# Staff Report

**REPORT NO.:** DSD-2025-116

**SUBJECT:** Minor Variance Application A2025-024 – 507 Stirling Ave. S.

Figure 2: Requested Variance for Accessory Building

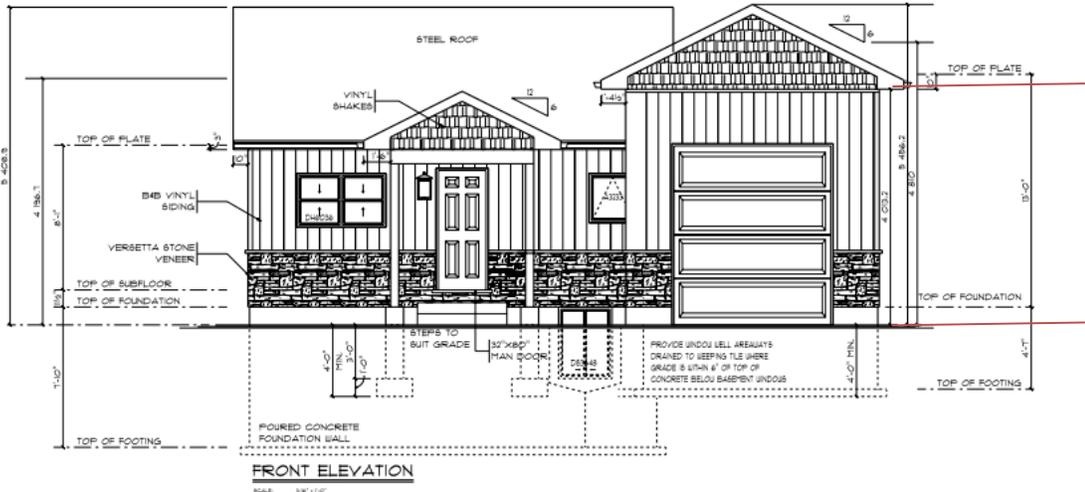
Variance for 4m fascia height

##### *Variance for the Accessory Building Fascia Height*

The intent of the maximum height to the underside of the fascia is to ensure that accessory building is not excessive in height and to ensure neighbouring properties do not have adverse impacts from large rear yard structures. The accessory building will be used strictly for vehicle storage, ensuring that it will not create any privacy concern to the neighbouring properties. Staff is of the opinion that the requested variance meets the general intent of the Zoning By-law.

The effects of the variance is minor in nature as there are no significant impact on the neighbouring properties. The accessory building with the proposed increased fascia height maintains a sufficient setback of 11.6 metres from the rear lot line which mitigates privacy concerns for the neighbouring properties as well as no windows to overlook the neighbouring property while using the accessory building.

The variance is appropriate for the development and use of the land as it will increase the usability of the accessory building on the subject property. The increased fascia height will allow the accessory building to be more functional and allow for efficient storage of vehicles.

Figure 6: Floor Plan of Proposed Structures

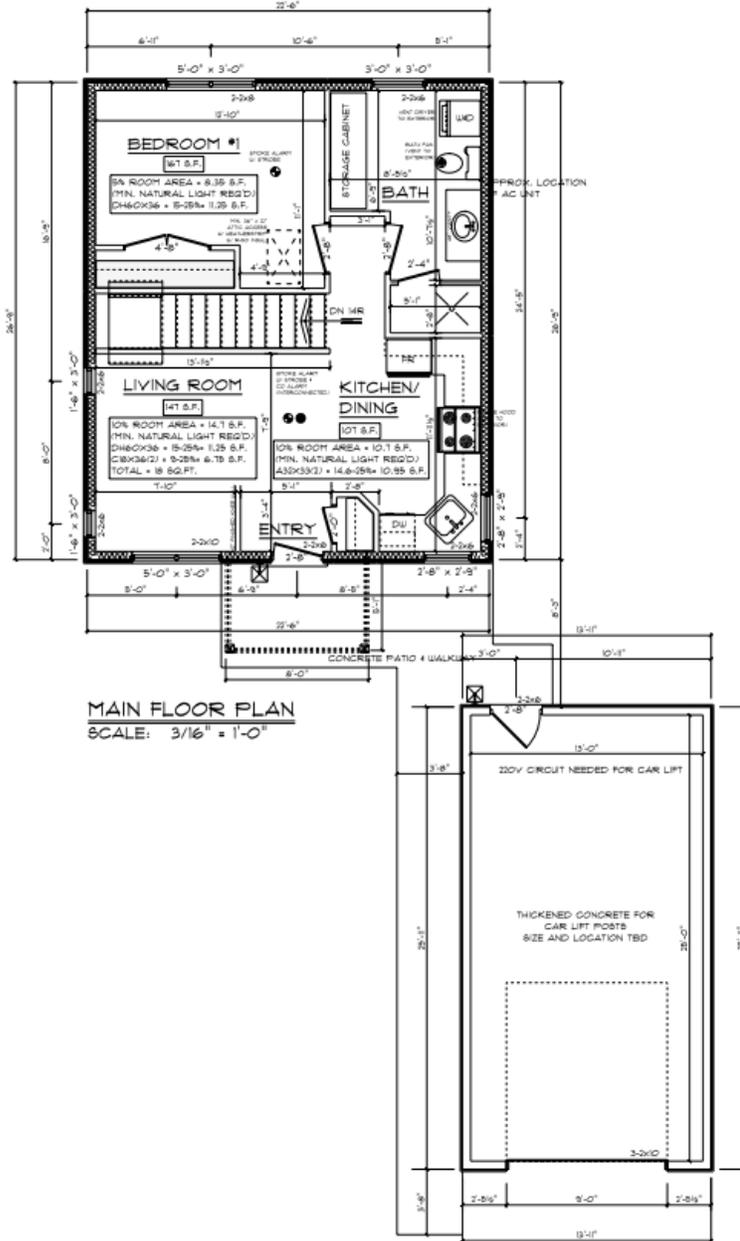
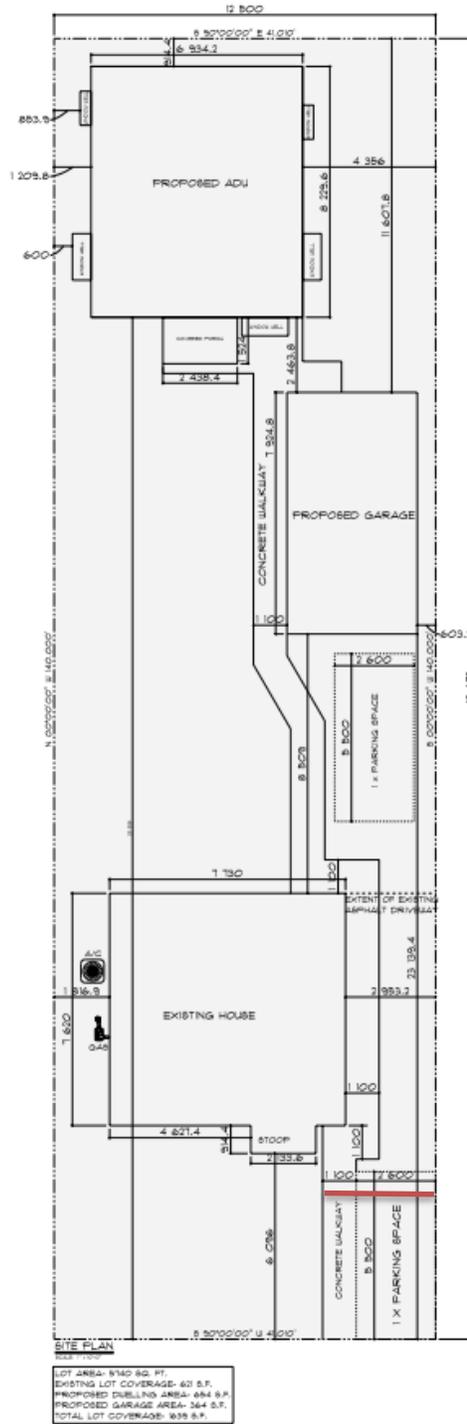
Variance for 1.1m shared walkway

Also, the City's Urban Design Manual prioritize pedestrian safety by mitigating potential conflicts with pedestrians and vehicles. The proposed 1.1 metre walkway is proposed to be shared with the driveway will not be unobstructed and may block emergency services access. Given this potential conflict, this variance will not meet the intent of the Official Plan.

The general intent of the Zoning By-law requiring unobstructed walkway is to ensure safe, accessible, and efficient movement for occupants of the ADU and emergency services can access the site efficiently. This includes ensuring that pathways are clear of physical obstacles, such as parked vehicles, debris, or structures, so people can walk freely without risk of injury. The provided walkway is not unobstructed, the Zoning By-law definition which states that the walkway must be "...unencumbered by obstructions including but not limited to: stairs, decks and porches (except those which form part of the path of travel to the principal entrance); parking spaces; driveways;..." In this case, parking spaces and the driveway encumber the walkway. Staff is in opinion that the proposed variance does not meet the general intent of the Zoning By-law.

Staff is in opinion that the effects of the variance are not minor in nature. The shared driveway obstructs the walkway, making it inaccessible for emergency vehicles causing a safety issue. As a result of the variance, there will be a conflict between pedestrian and vehicle use as neither walkway nor the driveway will be able to function independently.

With no legal mechanism to enforce no-parking in the driveway where the walkway is proposed to be located, fire would not support the combined walkway and driveway. The proposal does not comply with the Emergency Services Policy because the ADU is approximately 37 metres from the principal entrance, whereas the emergency service policy restricts this distance to a maximum of 30 metres for dwelling units with direct access to the outside from the unit. If the exit/principal entrance is shared by two or more units that distance is reduced to 15 metres.

Transportation Services does not support the proposed garage or parking space location at the rear of the property. Vehicles accessing the parking space or garage must drive over the walkway, and occupants may not be aware to keep this walkway unobstructed of parked vehicles. Obstructions of the walkway may block emergency services accessing the ADU.
